Agenda
Village of Arlington Heights
Design Commission
Community Room, 3rd floor

Item: DC#19-036 - Arlington Heights Promenade - 305 E. Rand Rd. /
Commercial

Approval of the proposed architectural design for exterior modifications to an existing retail building.

2 PROPOSED ELEVATION

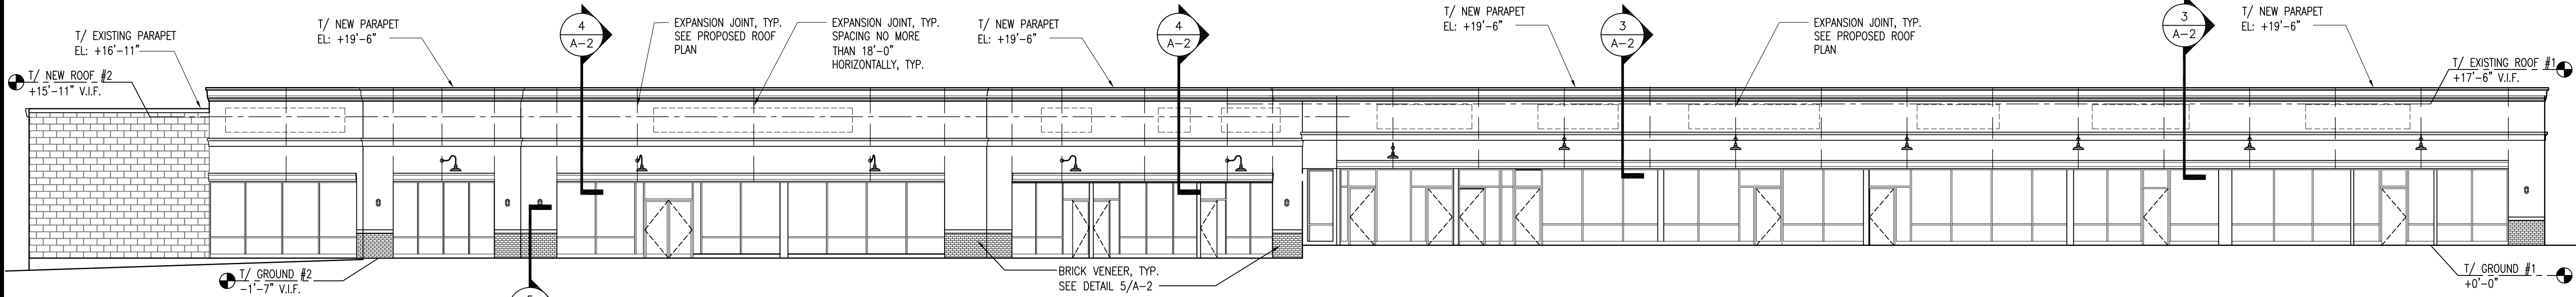
The proposed design and new materials will provide a welcome refreshing for the building. The EIFS and stone colors have been selected to coordinate with the existing tan split face CMU on the side walls of the building, which will remain. The existing tenant wall signs will remain. Overall, the new façade is nicely designed. The decorative EIFS cornice and banding will add depth and interest to the existing flat wall. A minor correction to the architectural drawing is required to show the middle EIFS band on top of the new wall surface, not recessed into it.

1. Correct the architectural drawing to show the middle EIFS band on top of the new EIFS wall surface, not recessed into it.
2. Change the wall sconces for the piers between the storefronts from the "Neptune Collection" to a more decorative style fixture that fits with the building design, to be approved by Staff.

Neptune Collection

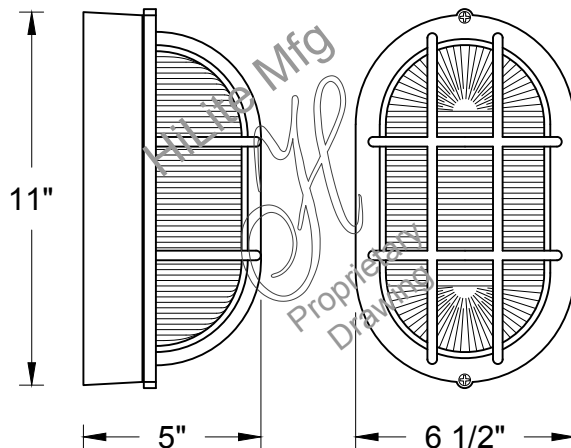
The only other comment on the proposed design is that the "Neptune Collection" wall sconces proposed for the piers between the storefronts have an industrial appearance that does not fit with the design. A nicer, more decorative style wall sconce is recommended, to be approved by Staff.
